MIL-F-48877 (AR)
AMENDMENT 8
2 MARCH 1990
SUPERSEDING
AMENDMENT 7
22 MARCH 1985

MILITARY SPECIFICATION

FUZE, ROCKET: M439 PARTS AND ASSEMBLY WITH DETONATOR

TABLE V First article test

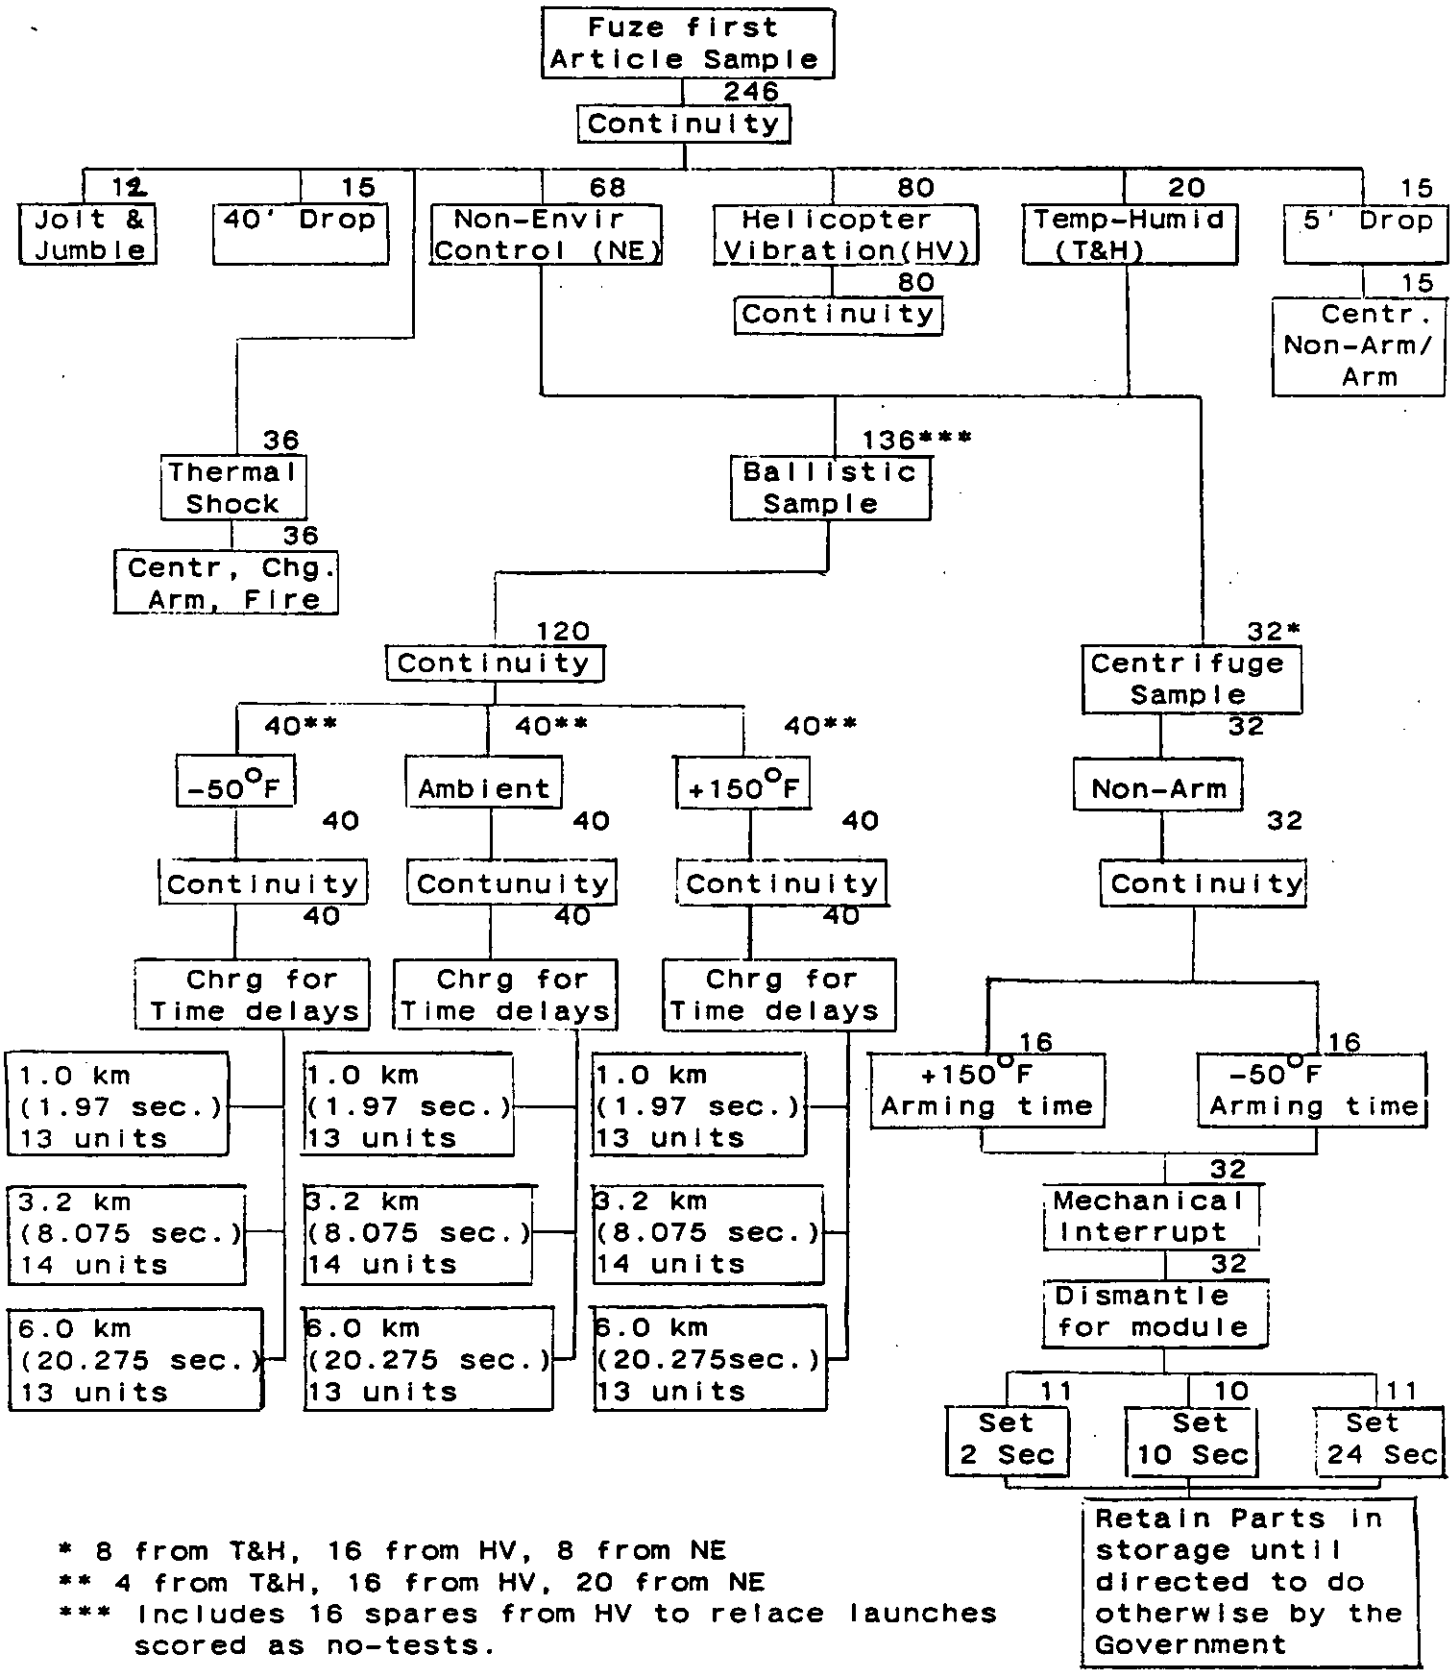
* TABLE V: Delete in its entirety and substitute included PAGE (81).

* 8 from T&H, 16 from HV, 8 from NE
** 4 from T&H, 16 from HV, 20 from NE
*** Includes 16 spares from HV to relace launches scored as no-tests.

Note: A setter that represents the helicopter setter system shall be used for delay time acceptance tests in all cases.

TABLE VII Fuze lot acceptance test

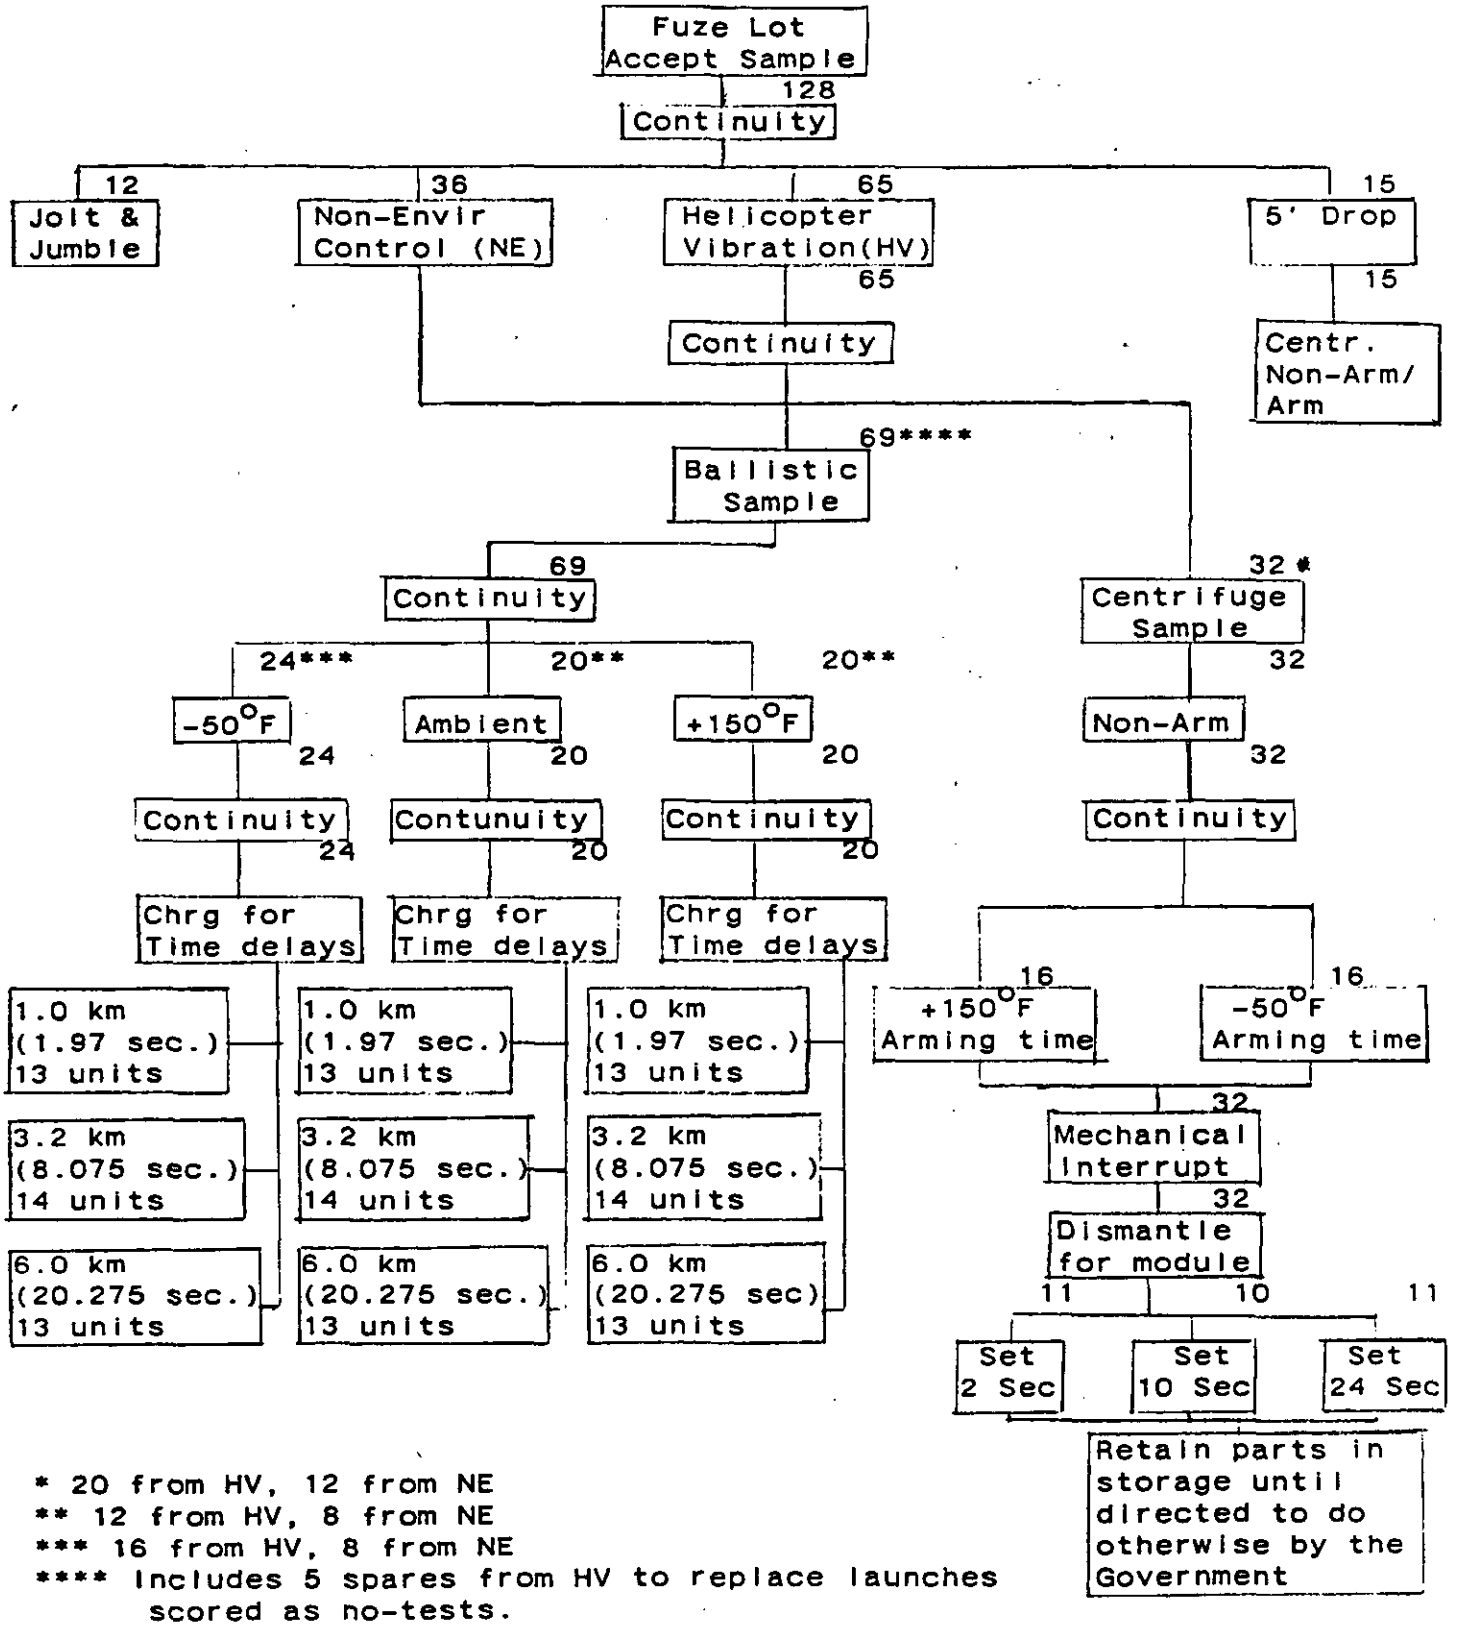
* TABLE VII: Delete in its entirety and substitute included PAGE (84).

* 20 from HV, 12 from NE
** 12 from HV, 8 from NE
*** 16 from HV, 8 from NE
**** Includes 5 spares from HV to replace launches scored as no-tests.

Note: A setter that represents the helicopter setter system shall be used for delay time acceptance tests in all cases.
